| Office Action Summary | Application No. 10/570,821 | Applicant(s) BECKER-WEIMANN, KLAUS | |

DETAILED ACTION

Figure 2 of *Belanger*, as annotated by examiner

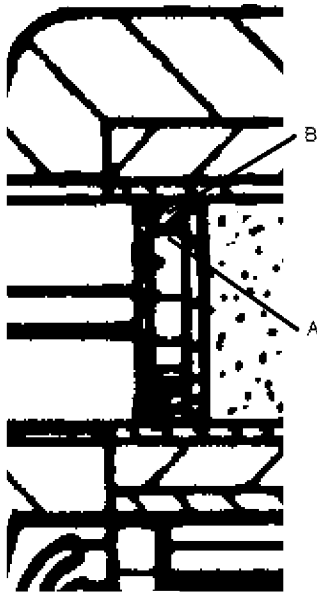
Applicant argues on page 7, lines 23-26, that “*Belanger* does not disclose a ram that acts on a small surface of the plunger, which is less than the full surface of the plunger” and then applicant refers to Figure 2 of *Belanger* as evidence. Examiner disagrees. Examiner has blown up and annotated Figure 2 of *Belanger* below to point out the reduced surface area of the ram acting on the plunger caused by the inclusion of the seal member 30 (A represents the end of the ram which transitions to the cross-hatched seal member B (30)).
